Product / Process Change Notification (PCN)

PCN #: PCN_FeSTAR-CLIP_20231006

Affected Series: WE-STAR-CLIP; 7427711; 7427713

To ensure an improved product assembly, Würth Elektronik will improve the design of the screw fixation area.

Valid for 7427713

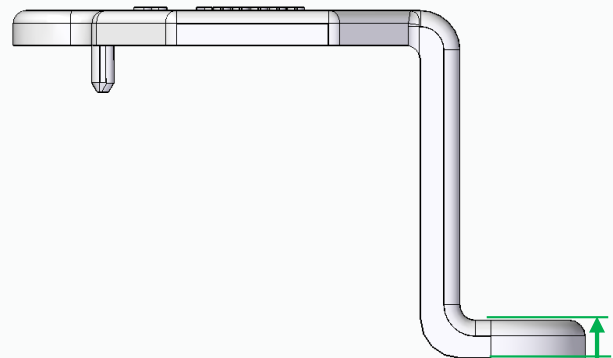
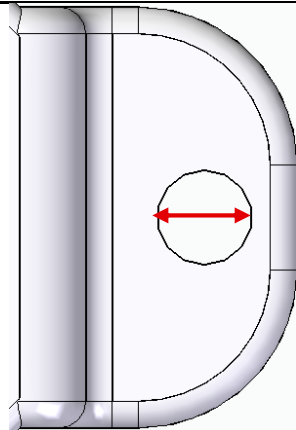
Thickness of the screw fixation area was **2.20 mm**

Thickness of the screw fixation area will be **2.40 mm**

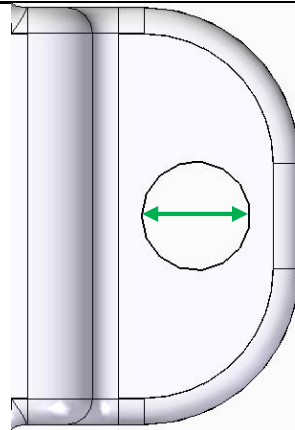
Borehole diameter was **3.60 mm**

Borehole diameter will be **4.20 mm**

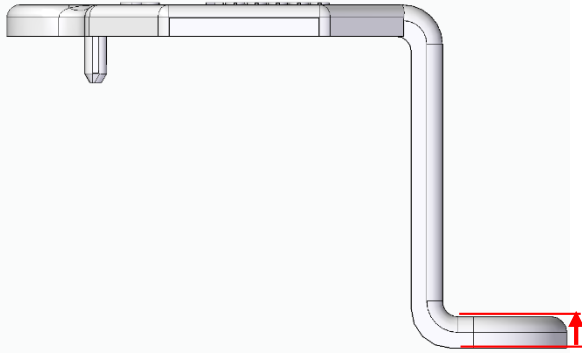
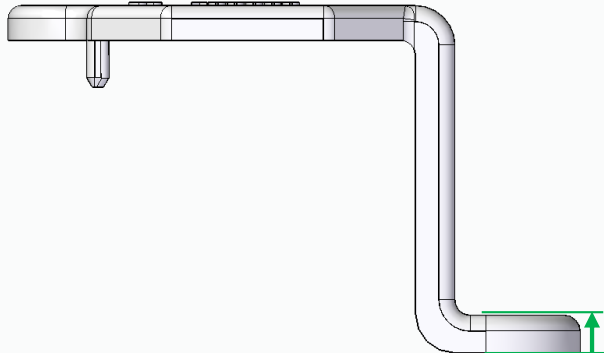
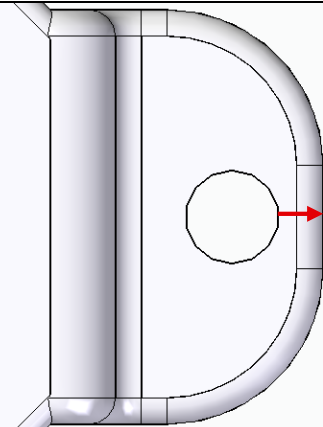
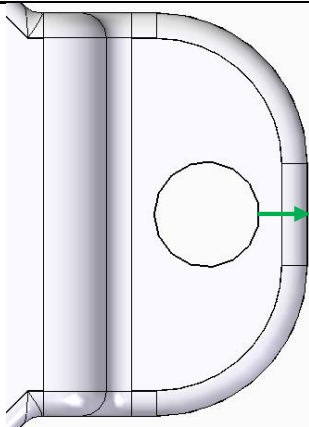
Valid for 7427711	
BEFORE CHANGE	AFTER CHANGE
 Thickness of the screw fixation area was 2.20 mm	 Thickness of the screw fixation area will be 2.40 mm.
 Distance between borehole and edge was 1.50 mm	 Distance between borehole and edge will be 1.90 mm
Reliability / Qualification Summary: Product approval is according to the specification criteria and is internally released by the Product Management Department. The following items are part of the internal release process for this change: - Visual Appearance (Surface, Burr, Contaminations, ...) - Mechanical Parameters (according as specified in the Datasheet) - Approval of production line
